SR 525

MUKILTEO FERRY TERMINAL (PHASE 2) FERRY TERMINAL CONSTRUCTION

VOLUME 5 OF 8

VOLUME 5 SHEET INDEX

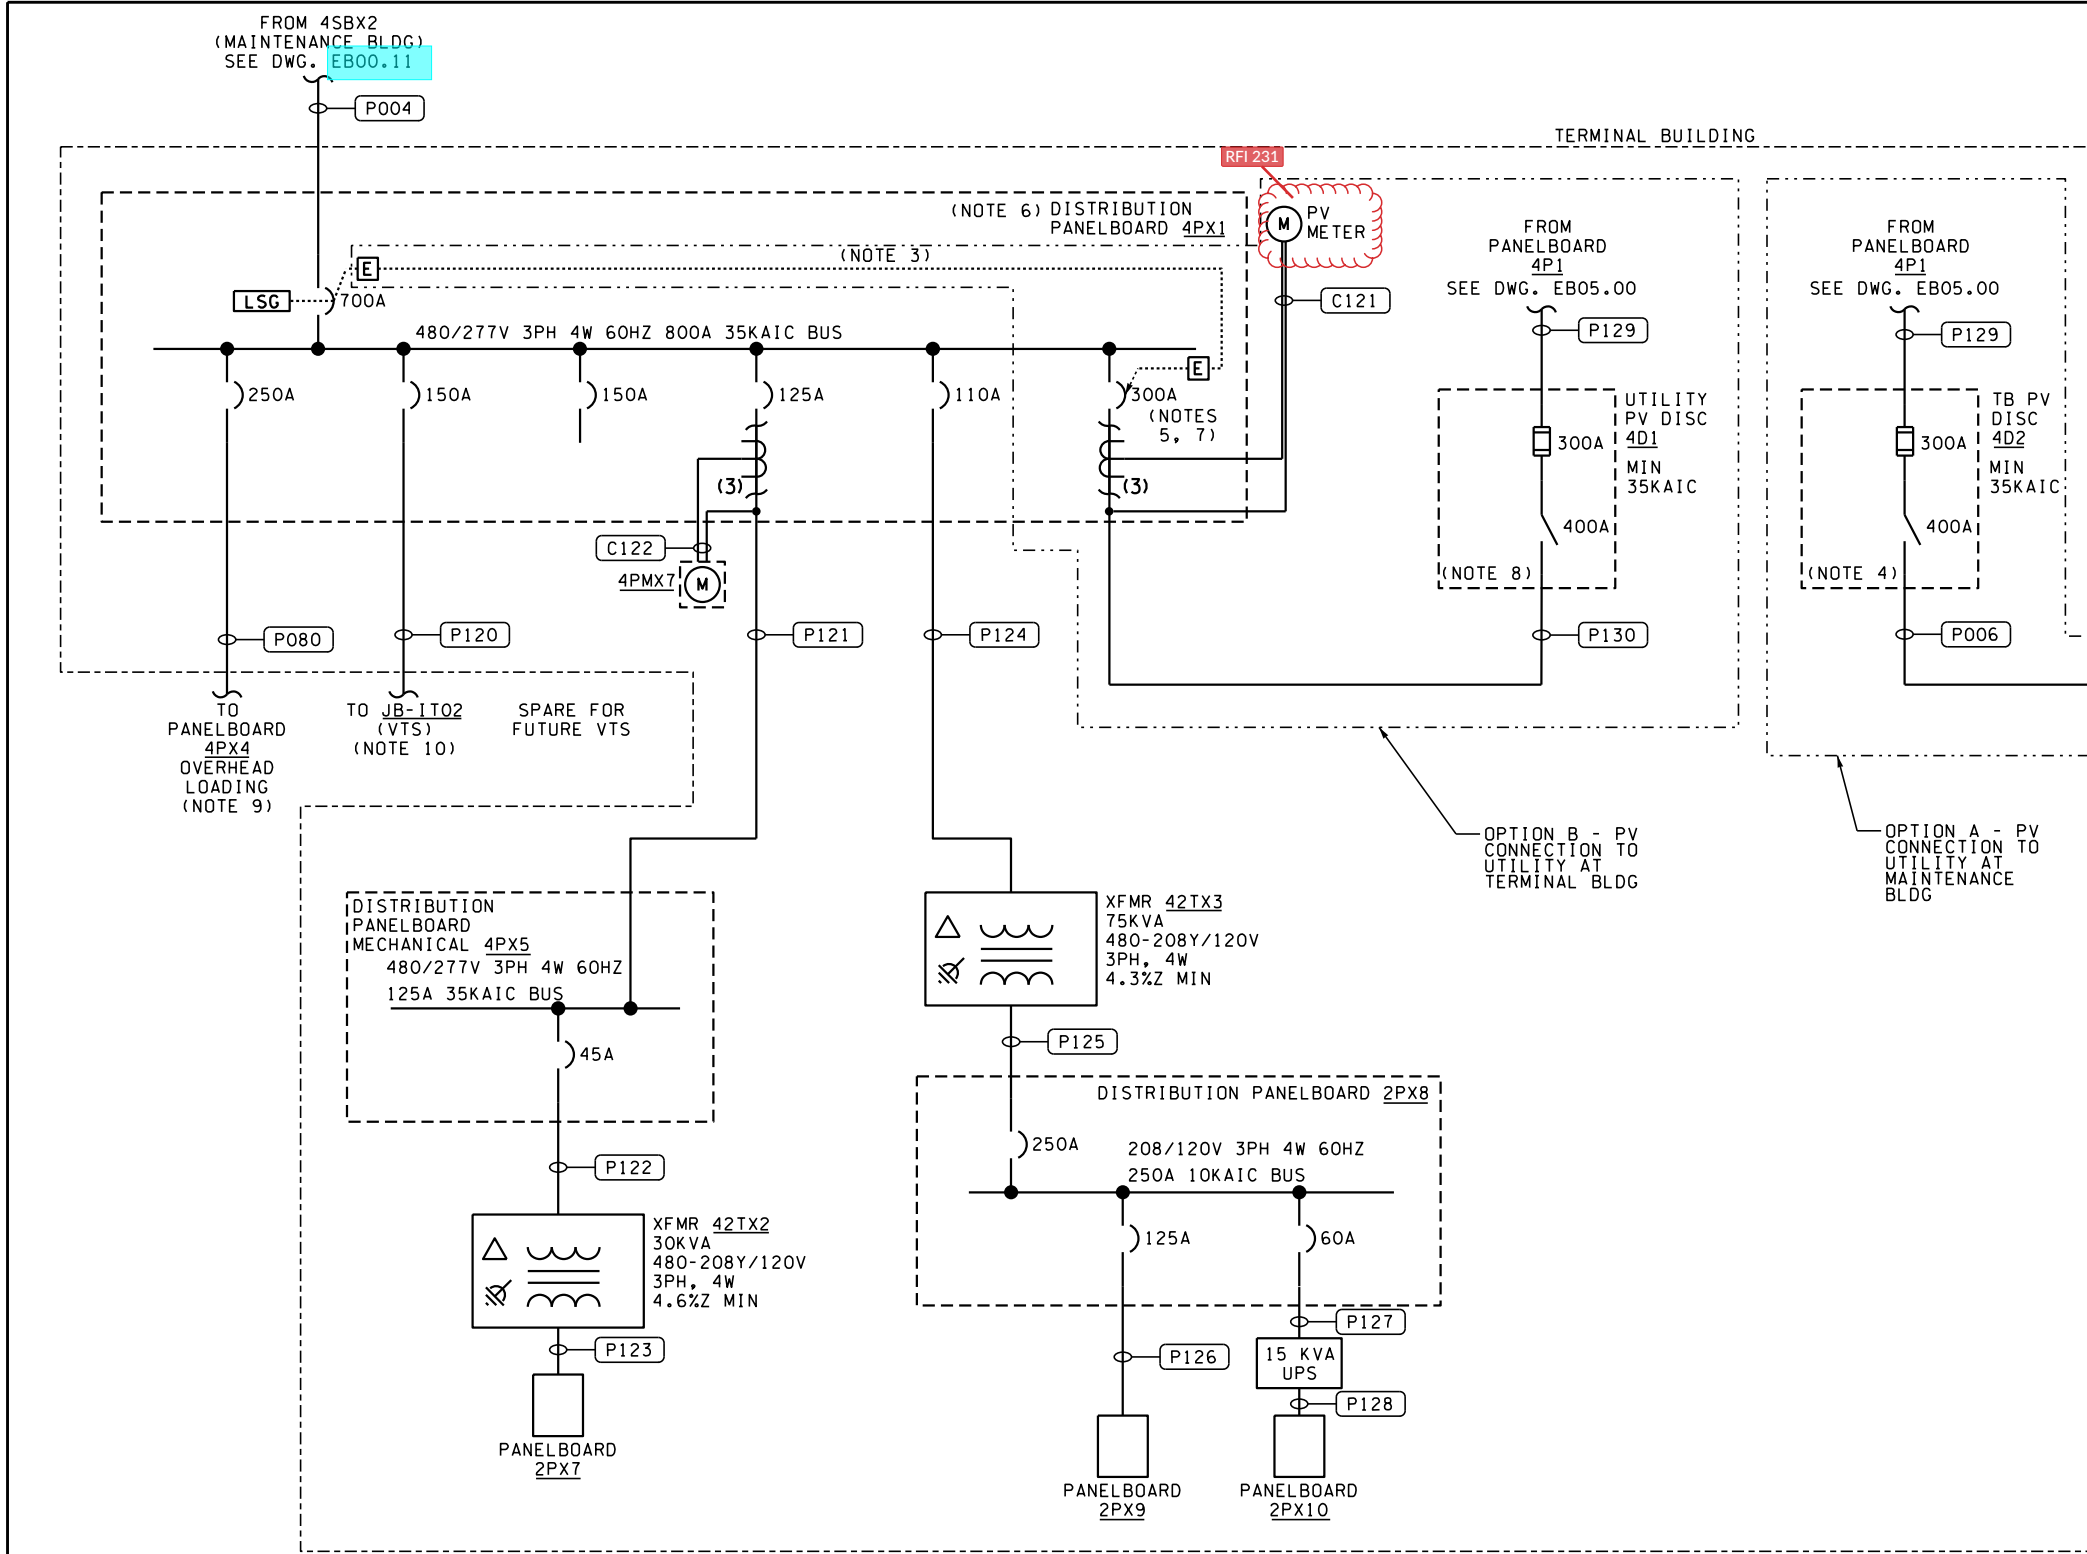
Per RFI 030, "Option A" shown on drawing EB00.11 has been selected for the solar connection. The PV meter shown on EB00.13 was part of "Option B" and has been removed from the design. FSi has agreed that the meters shown on drawing EB00.11 should be monitored by DDC.

1 LEVEL 1 SECTOR A LIGHTING PLAN

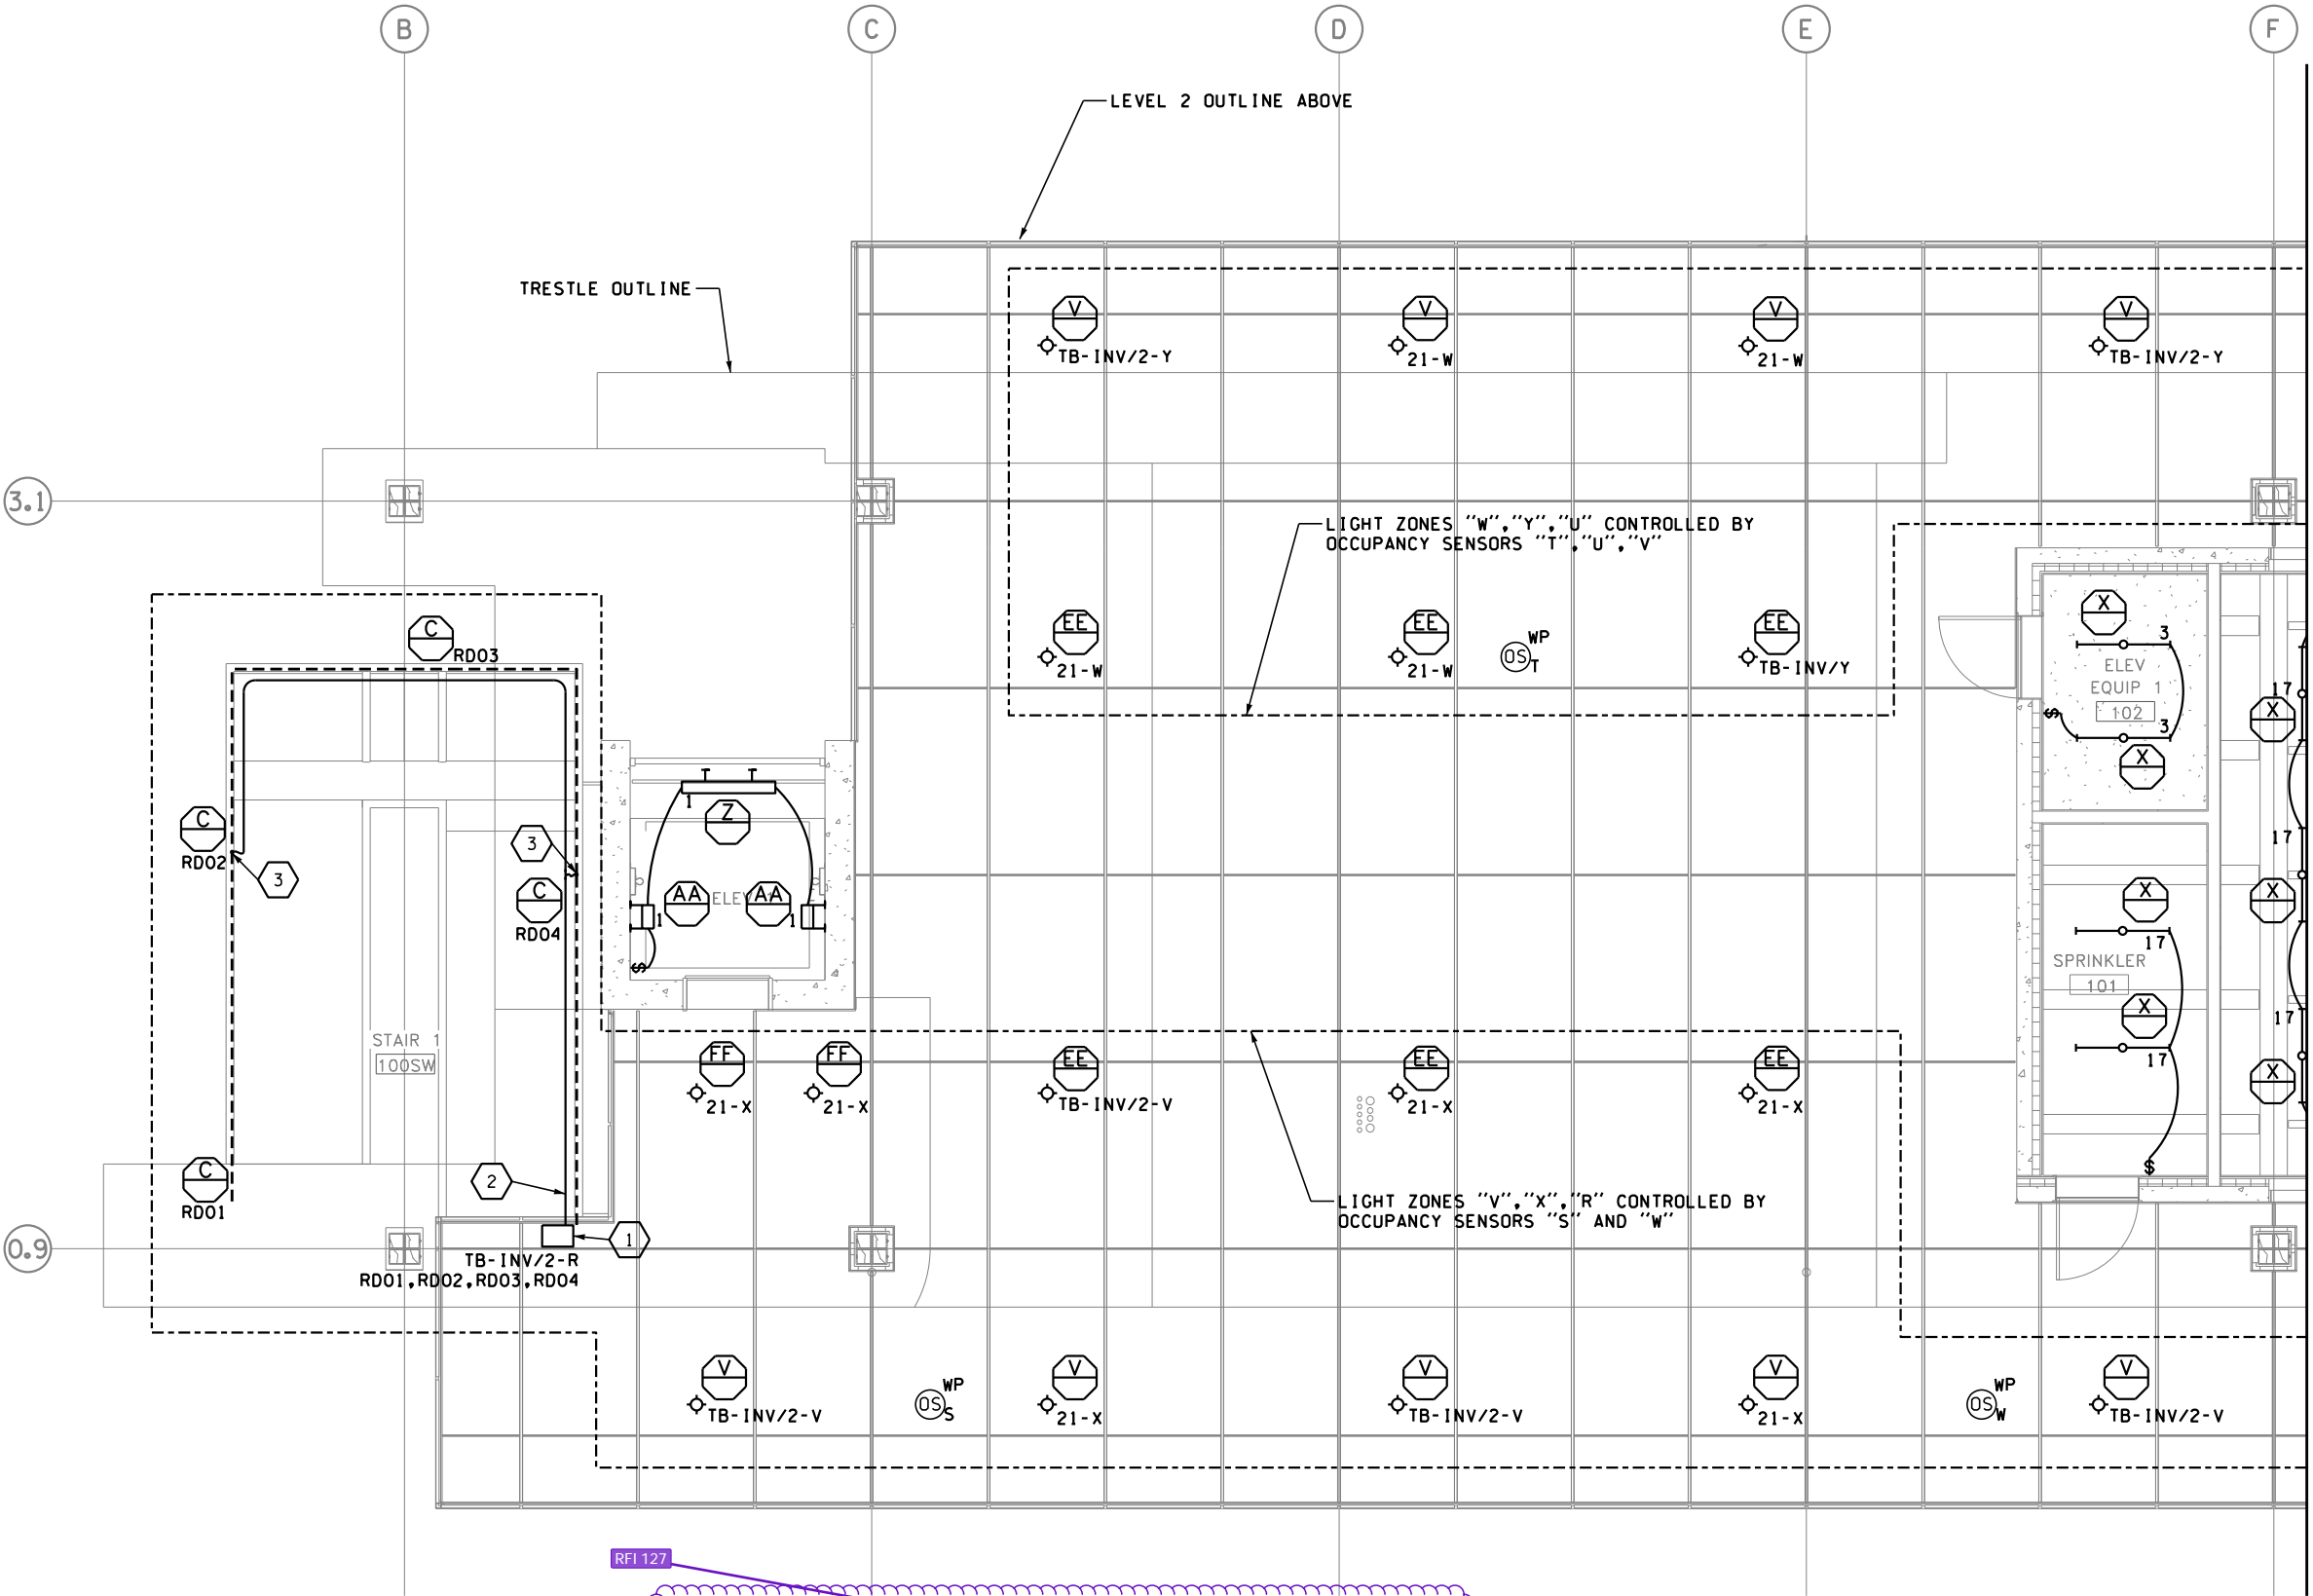
RFI 127 - Additional Guardrail Questions
Sheets A04.11, A06.17 and A06.18 have been revised as part of the response to this RFI.
1. See 1/SB06.09

2. Center to center dimensions between LIGHT ZONES "W", "Y", "U" CONTROLLED BY OCCUPANCY SENSORS "I", "U", "V"
OHL should be 16'-3". OHL is 14'-10" wide and per detail 5/A06.17 plate is 8 1/2" from edge of OHL. However, detail 5/A06.17 needs to be revised since a knife plate can not be attached to the edge of the OHL threshold. Please send new RFI to track that revision.

4. HDRL-4 is a stainless steel handrail with integrated lighting - see fixture type C in the luminaire schedule on EB07.00 and lighting plans EB08.01, 08.02 and 08.03. Coordinate handrail bracket with fixture and conduit location. Design intent is for bracket to weld to the bottom of the SST bar that supports HDRL-2. The proposed detail in this RFI is not acceptable. HDRL-2 and HDRL-4 and the bracket for HDRL-4 and the SS1 bar (2"x4"x1/4" thick) that supports HDRL-2 (detail 4/A06.18) are the exception to the exposed metal receiving GPC-1 - these elements should remain unpainted no. 4 finish stainless steel.

5. Guardrails must meet code and be min 42" above finished floor. Increase height of guardrail infill from 2'-8 3/4" to 2'-9" to increase overall height of GDR-1 in detail 3/A06.17 and from 2'-6" to 2'-9" in detail 2/A06.18, with the gap between the top of channel at slab edge and the infill panel reduced to 2'-3 3/4" from 3'-1 1/2". This will create consistently sized infill panels.
